## Technical change to FieldPower® (GHDE)

Please pass on this Product Change Notification (PCN) to your employees and, if applicable, to your customers.

#### 1. All size 1 boxes:

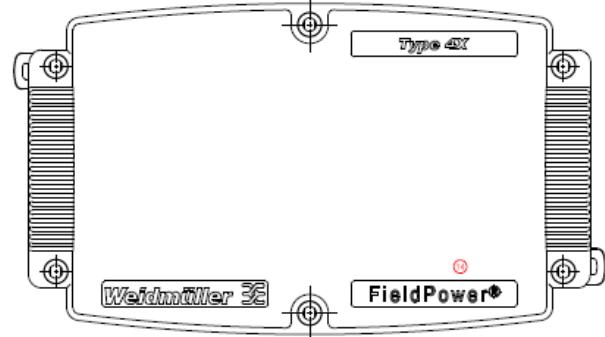
Assembly instructions are removed, Fieldpower lettering is adjusted, sticker groove is removed.

#### 2. Additional for all size 1 fuse boxes:

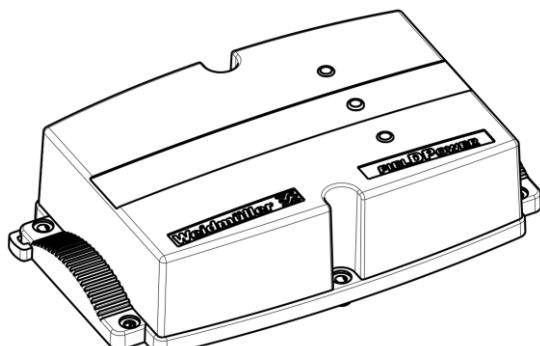
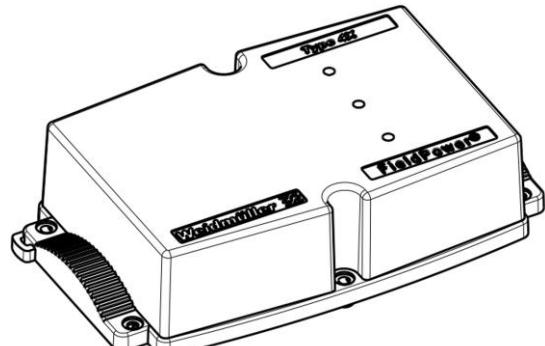
Cover surface and side surfaces were straightened
